# City of Corpus Christi

1201 Leopard Street  
Corpus Christi, TX 78401  
cctexas.com

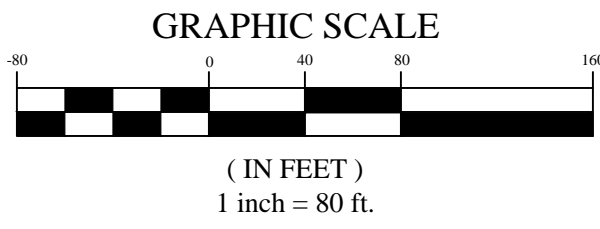
Comment ID	Page Reference	Annotation Type	Author : Department	Status	Review Comments	Applicant Response Comments
21	Plat1	Note	Justin Phung : Default	Closed	PW STR: Informational: Based on the Corpus Christi GIS Viewer, Airport Rd (FM 665 between Baldwin Blvd and Morgan Ave) is TxDOT jurisdiction. Please coordinate with TxDOT.	
22	Plat1	Note	Justin Phung : Default	Closed	PW STR: Informational: A person shall be held responsible for damage to and in public right-of-way for the criteria outlined in Sec. 49-39-9 in the City's Municipal Code and will be held responsible for restoring the City assets per Municipal Code Sec. 49-47-1, Sec. 49-54-6 and Sec. 49-49-3. For further information, please email ROWManagement@cctexas.com.	
15	Plat1	Note	Bria Whitmire : DS	Closed	<p>Sidewalks are required per UDC 8.2.2.A.1.a: Within industrial subdivisions, sidewalks having a width of not less than 4 feet and thickness of not less than 4 inches shall be required only on streets that meet any of the following conditions:</p> <ul style="list-style-type: none"> <li>i. Streets that are in the Urban Transportation Plan as arterials or collectors;</li> <li>ii. Through-streets that either are connecting to existing streets or to proposed arterials or collectors; or</li> <li>iii. Perimeter streets where a sidewalk presently exists to the boundary of industrial subdivisions.</li> </ul> <p>Per UTP, Baldwin is an A1 and Airport is a C1, Beacon is a through-street connecting to existing streets, and sidewalk presently exists along Baldwin to the east and Airport to the north and south.</p>

Comment ID	Page Reference	Annotation Type	Author : Department	Status	Review Comments	Applicant Response Comments
20	Plat1	Note	Alex Harmon : DS	Closed	Add plat note: During the development of the site, any increase in stormwater runoff flow rates must be mitigated in accordance with UDC 8.2.8.A, 8.2.8.B, and IDM 3.05 resulting in no adverse impacts between existing conditions and proposed conditions.	
24	Plat1	Note	Mark Zans : DS	Closed	Label 20 Y.R. in Lot 5	
1	Plat1	Callout	Mark Zans : LD	Closed	Please check acreage being platted.	
2	Plat1	Callout	Mark Zans : LD	Closed	Please check acreage for plat.	
4	Plat1	Note	Mark Zans : LD	Closed	ROW comment: Baldwin Blvd. is a A-1 on the UTP and is to be 95 feet wide. A ROW dedication of 7.5 feet is needed.	
5	Plat1	Note	Mark Zans : LD	Closed	What is happening with the easement across the middle of the property.?	
7	Plat1	Note	Mark Zans : LD	Closed	Add block number 1
